**ADDENDUM NO. 1**

**CID 01-STILLHOUSE BRANCH WASTEWATER TREATMENT FACILITY  
IMPROVEMENTS**

**PROJECT NO.: 2-01590 | TWDB CWSRF NO. 73776**

**DATE OF ADDENDUM: MAY 24, 2023**

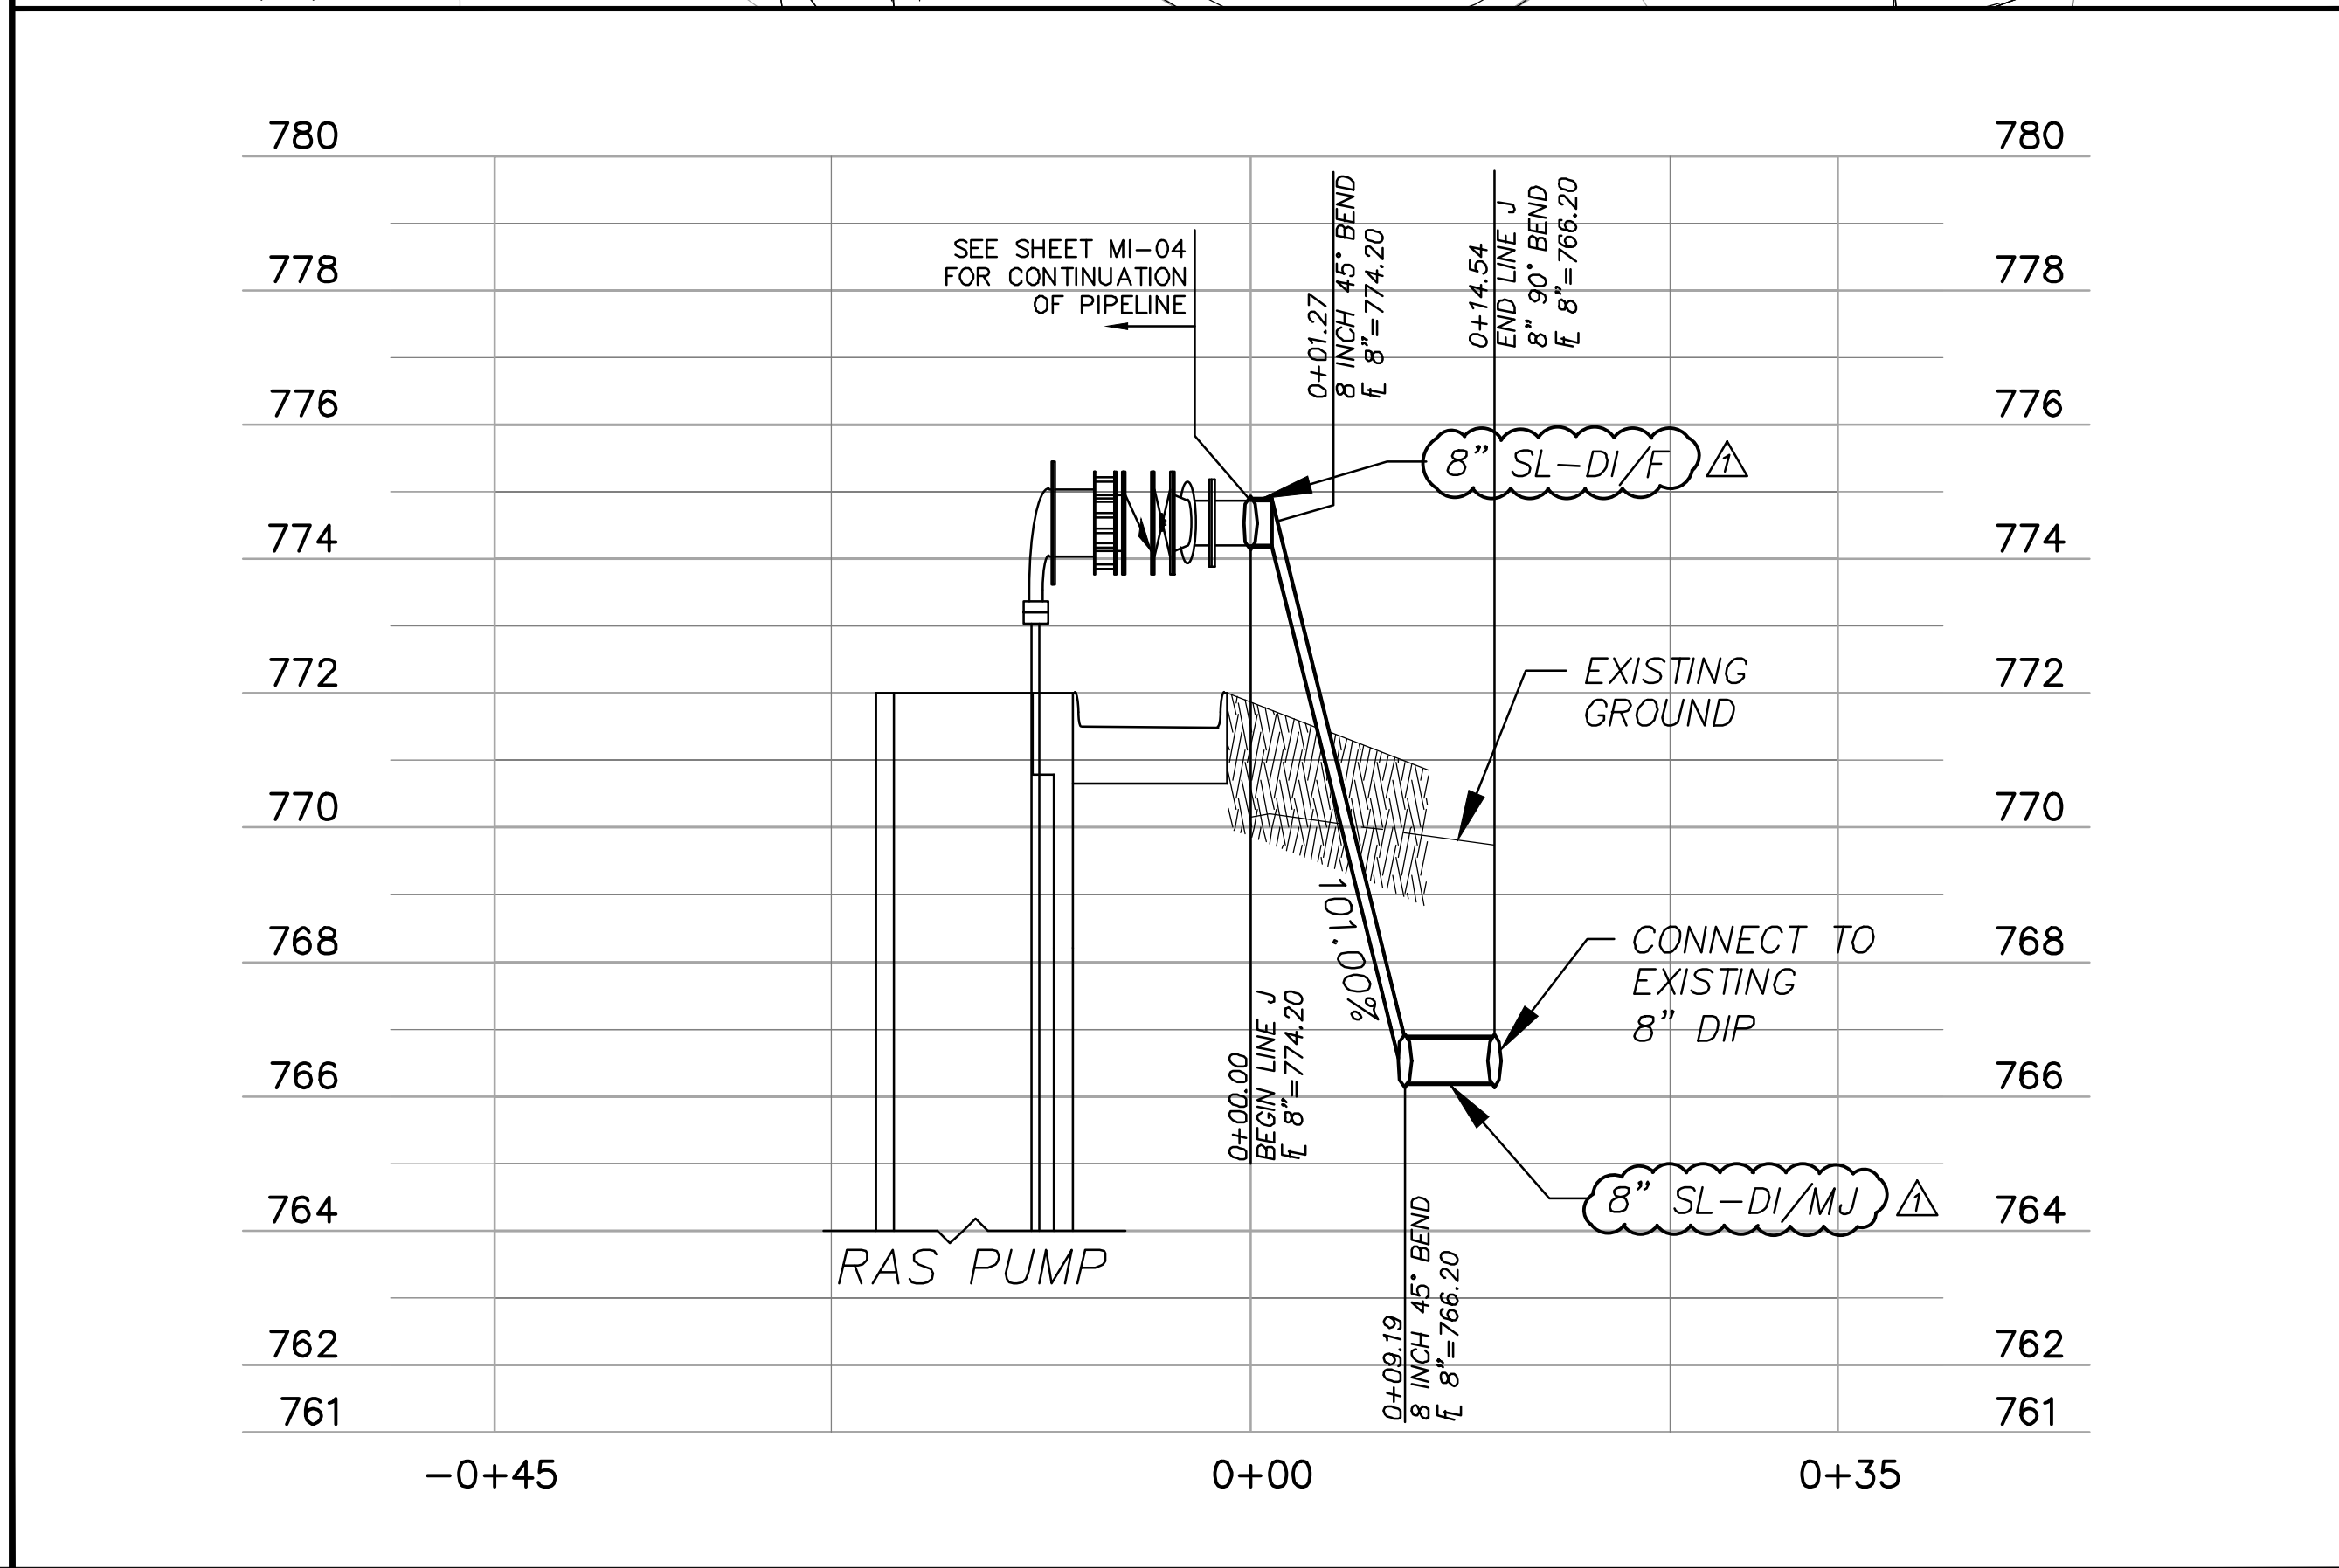
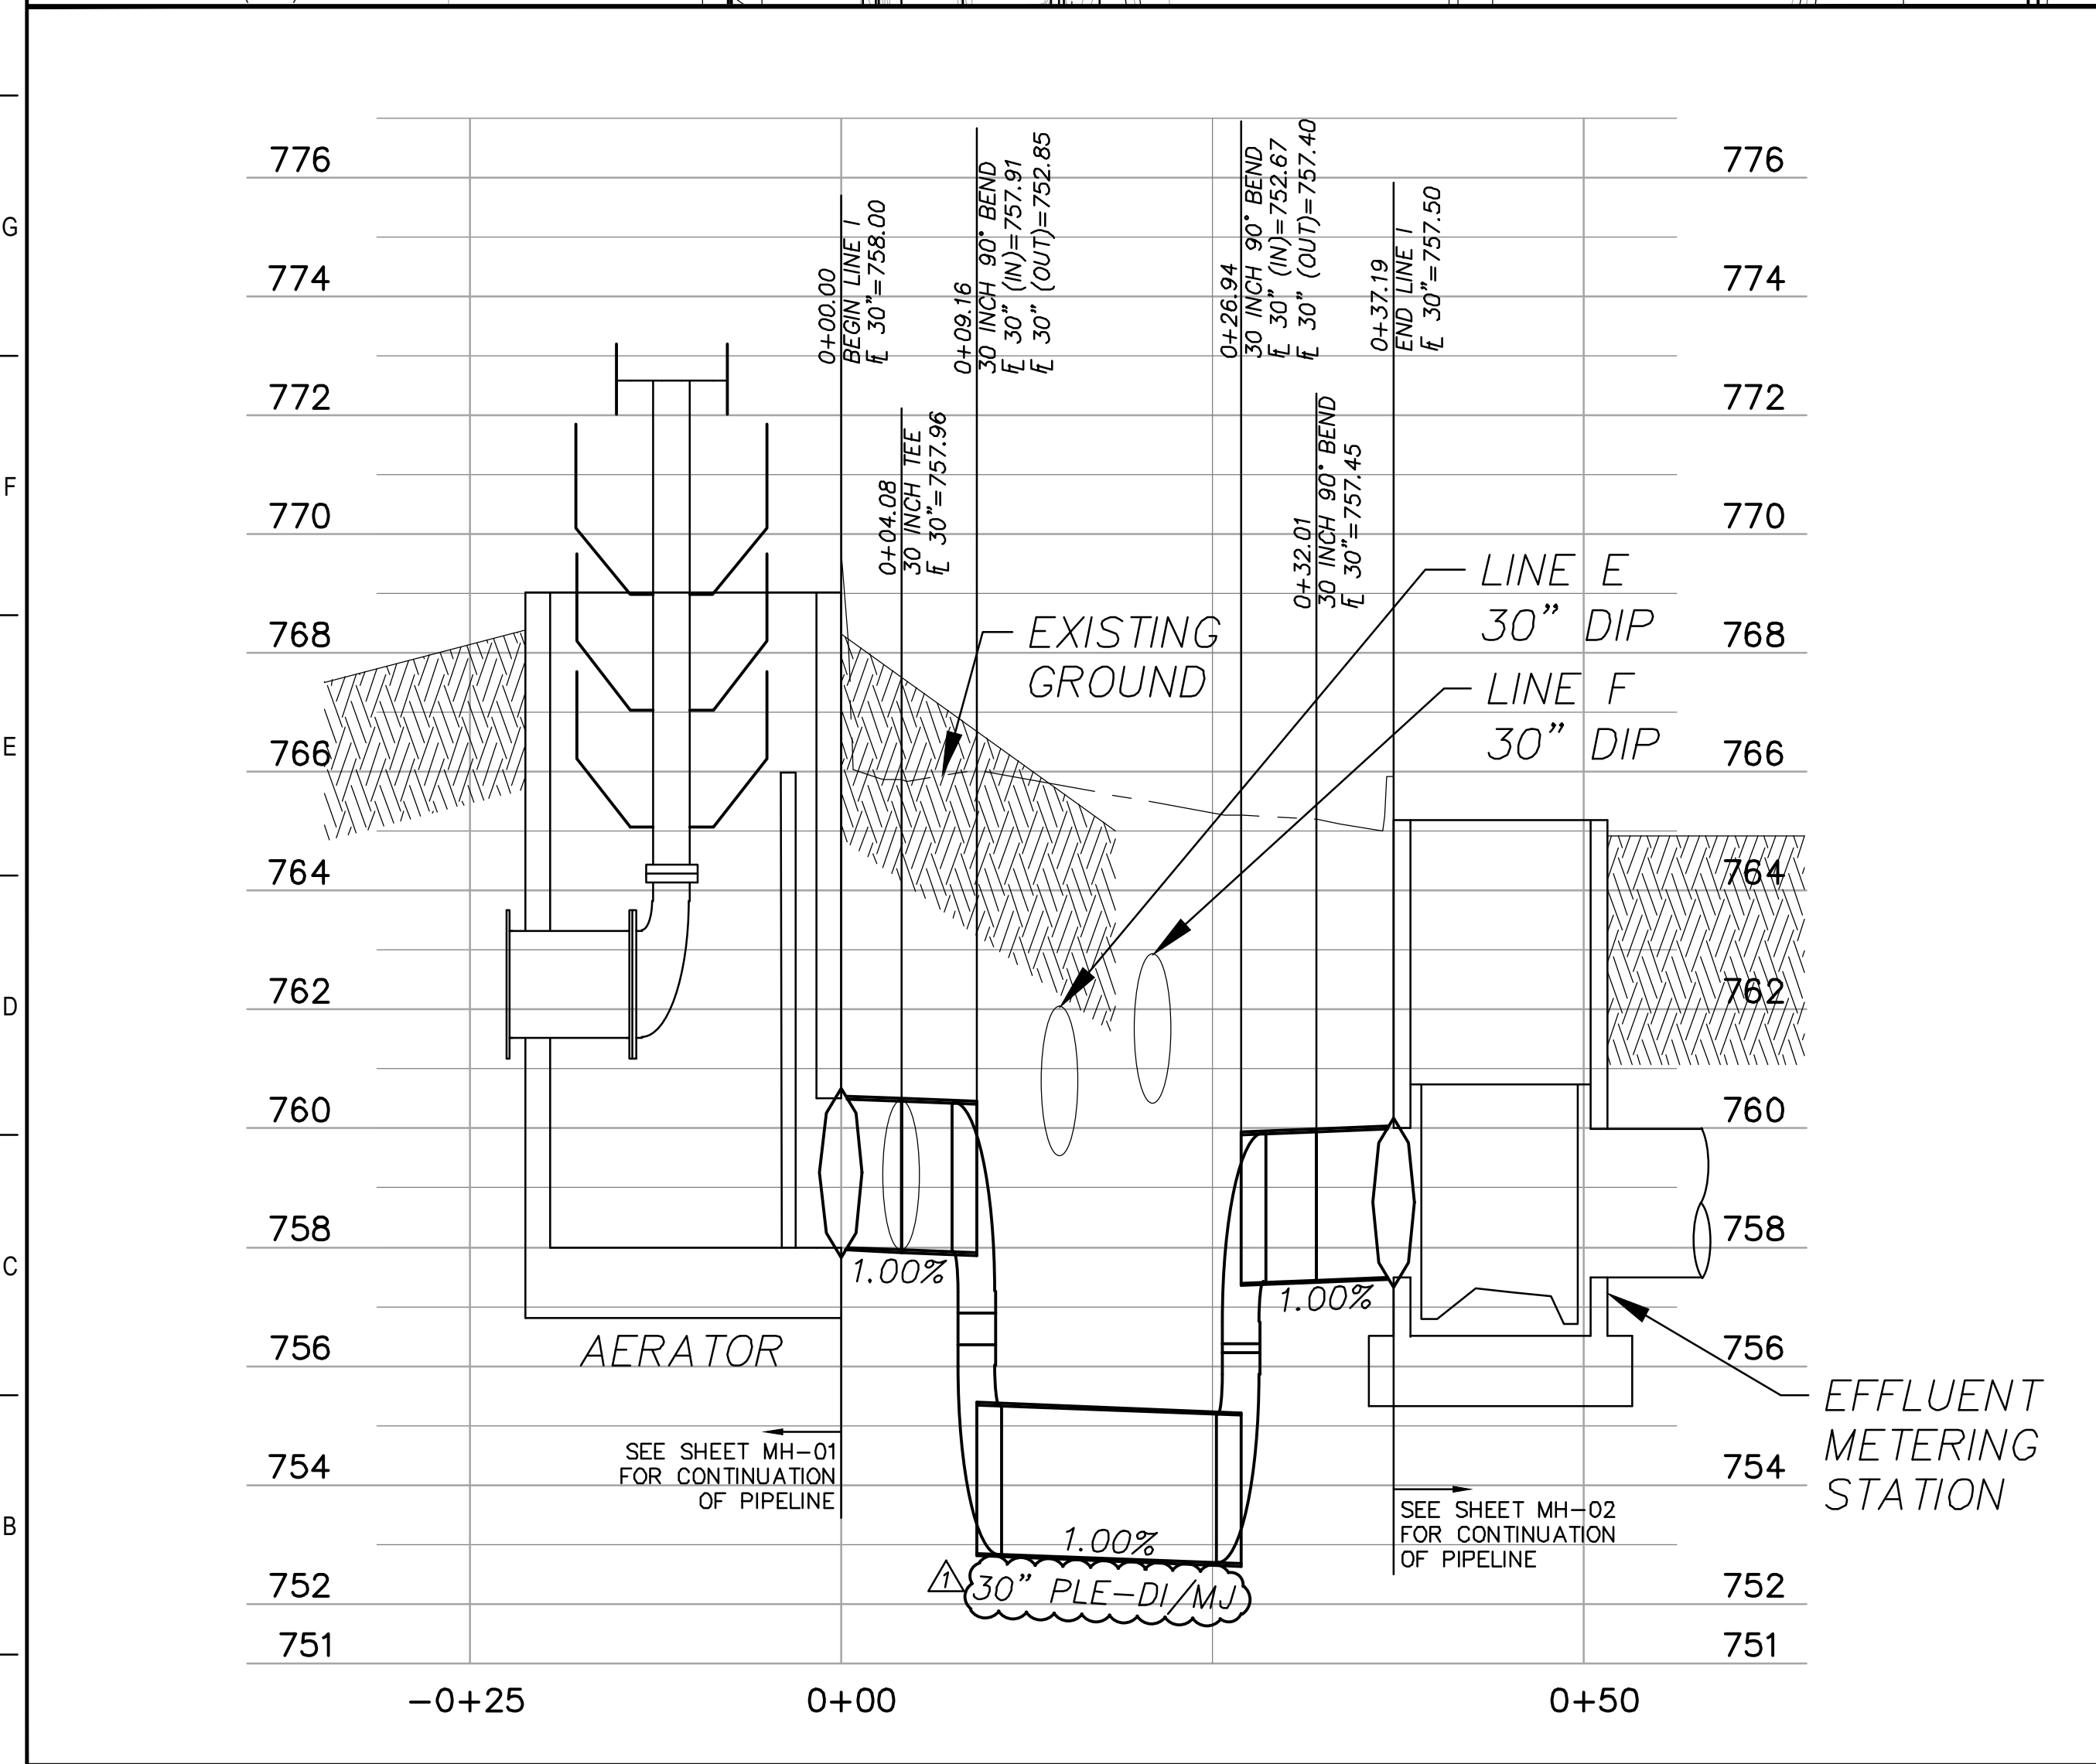
a. Sheets C-08 through C-17

REVISE yard piping to reflect the pipe labels on Sheet M-01 and Sheet M-02.
